TECHNICAL SERVICE BULLETIN

General Motors Quad 4 Installation Advisory – 2.3L (1987-1995)

AIRTEX PART NUMBER(S): AW5043

ASC PART NUMBER(S): WP-721

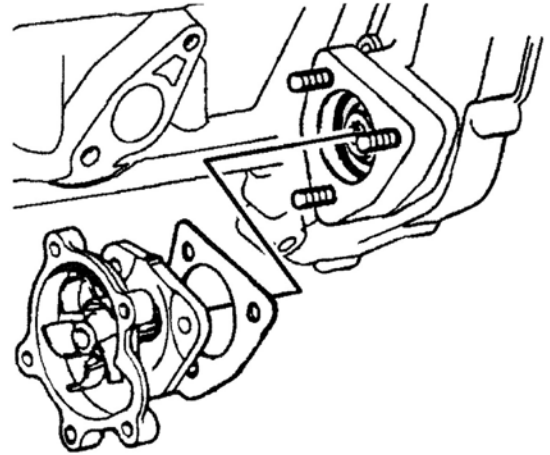
CONDITION: The replacement water pump bearing is pressed downward as the mounting bolts are tightened, damaging the bearing.

CAUSE: Improper seating of the water pump bearing shaft into the bore in the timing chain idler bearing.

CONDITION: The replacement water pump may not appear to seat fully, exposing a 1/4" gap between the timing chain cover and the pump's gasket surface.

CAUSE: The gap spacing is normal. The timing chain idler gear is internally spring-loaded to eliminate spline noise.

CORRECTION: To ensure proper installation, special attention must be paid to the proper seating of the splined end of the bearing shaft into the splined bore in the timing chain idler bearing.

CORRECTION: The gap will diminish as the pump is tightened down. The pump to timing cover mounting bolts should be tightened in a staggered, side-to-side fashion to their proper torque. Refer to the repair manual for proper bolt torque values.
